SECQ Test Method and Calibration Improvements

January 17, 2018

In support of comments 82-84

Case A SRS conformance signal
@ 1.7 dB SECQ
35 dB SNR, ~22 GHz Tx BW

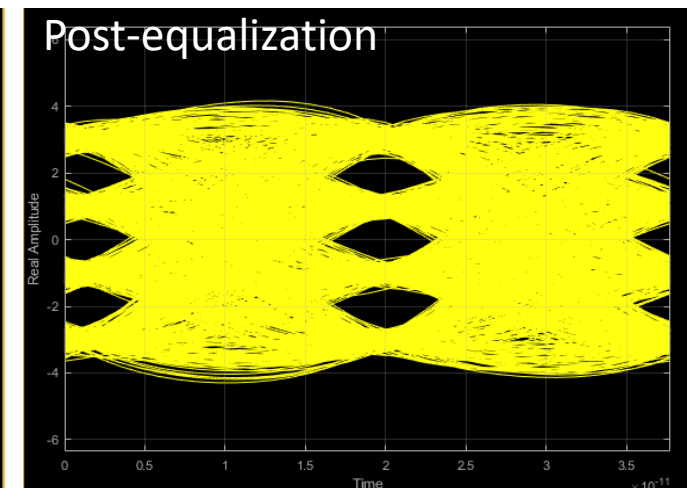
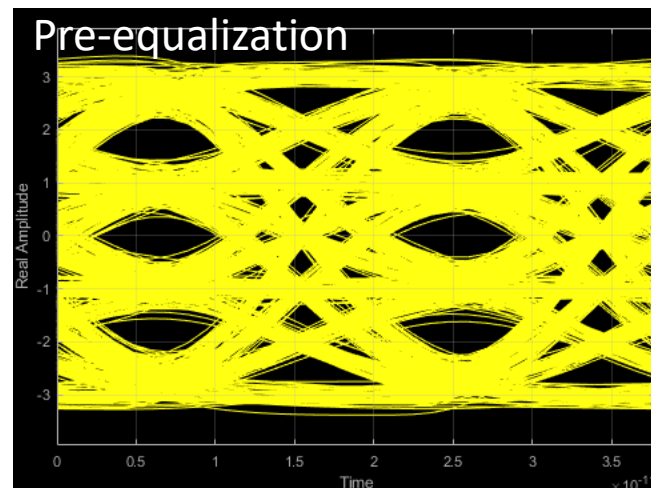
- Calibrating ISI-based “first 50%” of SECQ in accordance with draft standard gives two very different SRS conformance test waveforms
- Issue will be magnified when including allowed variance in remaining GN + SI SECQ stressors

Proposed Changes, in Pictures

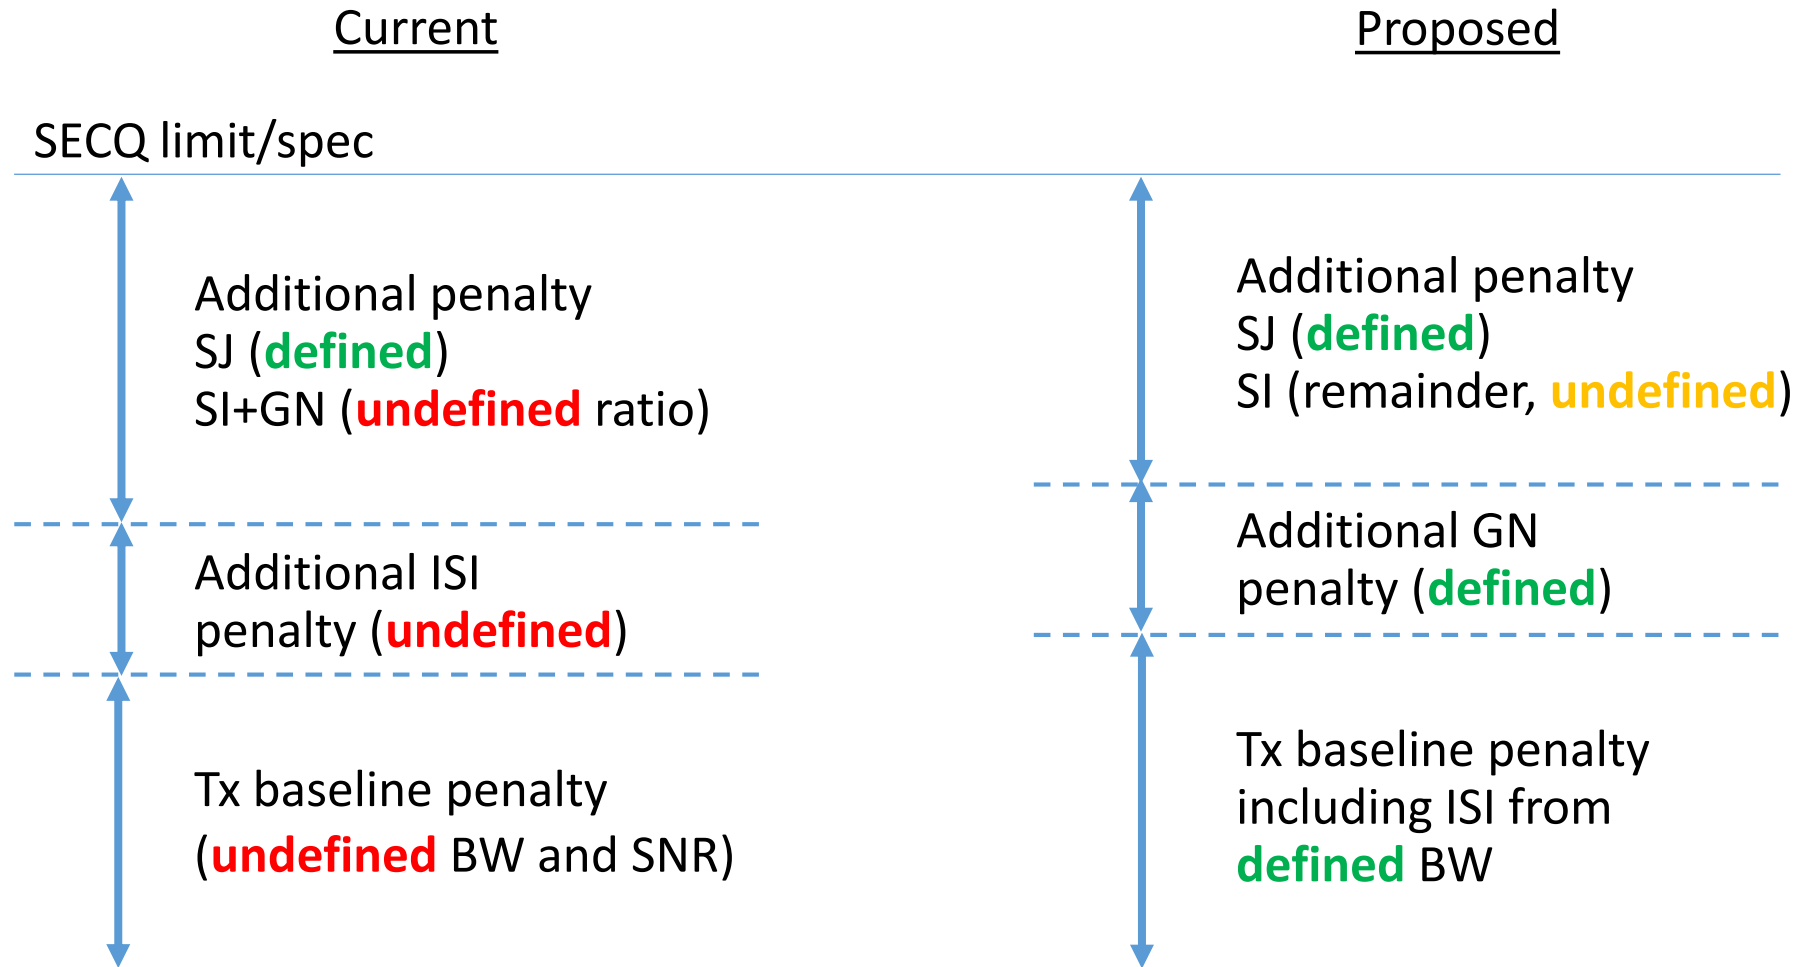
- Fix all degrees of freedom for SECQ composition except one, to get as repeatable and consistent an SRS conformance test signal as possible, rather than let everything float
- Ensure that as much as possible, various stress amounts track with actual expected values

- Specify a Tx bandwidth (13.25G for 50G/lane PAM4, 26.5G for 100G/lane PAM4) in place of the 50% ISI requirement
- Define a specific value for Gaussian noise to be added beyond baseline reference Tx + ISI SECQ (value in process, aim to tie this back to Tx with worst-case RIN value)
- Remaining SECQ comprised of sinusoidal interference and sinusoidal jitter (already defined separately)

Compare Two Cases with PRBS31Q

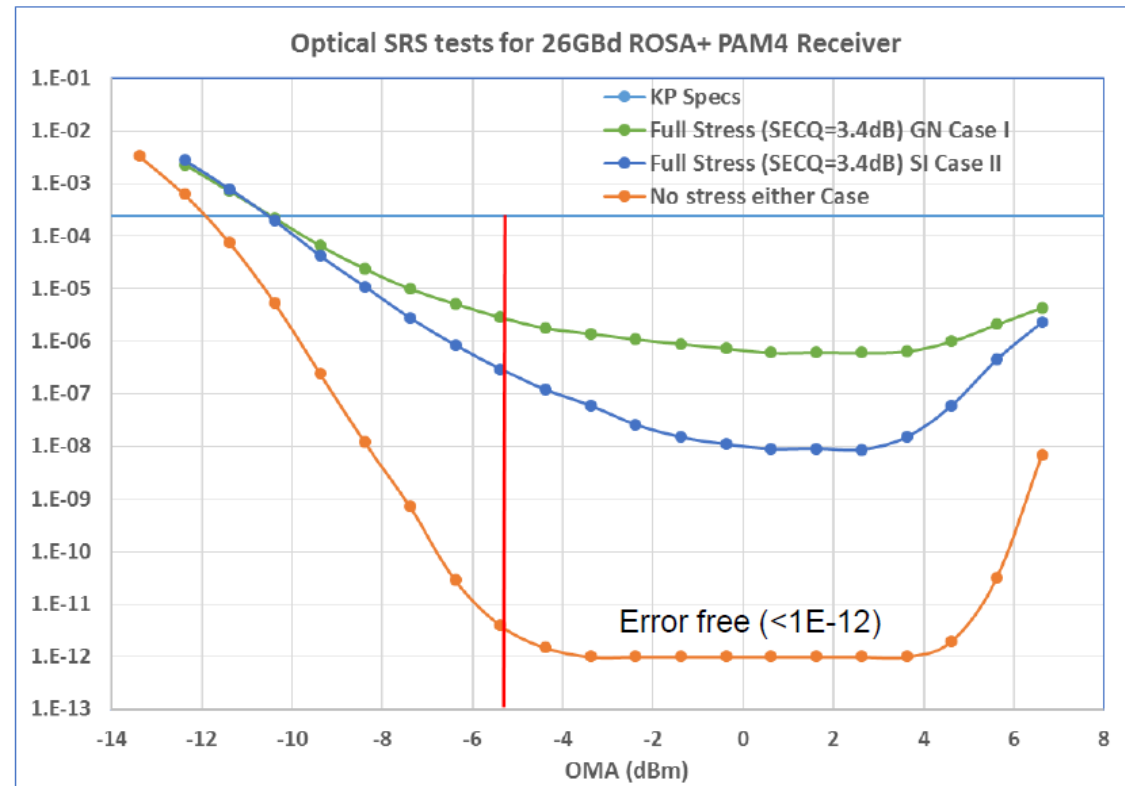
- Same SECQ=3.4dB but with different BER behavior
